Service Bulletin

Bulletin No. 2005-05 OEM No. 2005-05

4000 Series Panel Mount Control - Pistol Grip

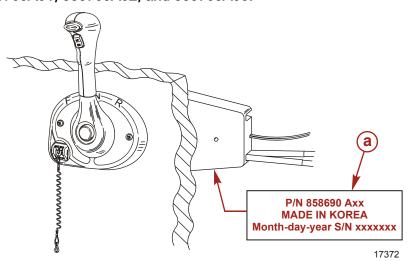
- 1. Have been installed in boats with the **last four digits** of the Hull Identification Numbers (HIN) between J000 (October, 2000) through F505 (June, 2005) are affected.
- 2. Have remote controls with dates of manufacture that are on the labels located as shown in the figure below between October, 2000 and May, 2005.

a - Label on bottom side of housing

Mercury Marine has identified a potential problem with the manufacturing of the 4000 series pistol grip panel mount remote controls. The amount of force required to move the shift handle out of the "NEUTRAL" detent lock position without depressing the release button, in a very small percentage of these controls, was found to be below specification.

Replace the handle and bezel on all controls that fail the test procedure listed above. Record the engine serial number and the boat HIN on the warranty claim form.

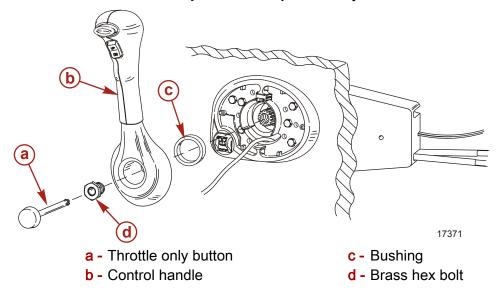
IMPORTANT: The main purpose of this test is to ensure that the neutral detent lock cannot easily be overridden without depressing the neutral release button.

- 1. Place the control handle in the "NEUTRAL" shift position.
- 2. Check the control handle for excessive free play. It should be minimal. If there is excessive free play, proceed to step 4.

- 3. Check the neutral lock by:
 - a. Cycling the control handle through its shifting range ("NEUTRAL" to "FORWARD" to "NEUTRAL" to "REVERSE" and back to "NEUTRAL") several times. Then place the handle in the "NEUTRAL" position.

- b. ONLY while seated in the driver's seat, push the control handle forward without depressing the neutral release button using normal pressure for operating the remote control. Do not strike or hit the handle. Handle lock should retain the handle in the "NEUTRAL" position.

- c. Use the same procedure for "REVERSE" direction.
 - d. If the handle lock does not hold the "NEUTRAL" position, replace the handle and bezel as described in the **Parts Required** section of this bulletin and submit a warranty claim under **Replacement**.

- e. If the handle lock functions properly, no further action is required.
- 4. If excessive free play is felt, it indicates that either the bolt that secures the handle to the control may not be fully seated or the bushing between the handle and bezel is missing. Either condition may allow the control handle to shift into gear without depressing the neutral release button while using minimal force. The excessive free play condition must be corrected before proceeding with any testing as described previously.
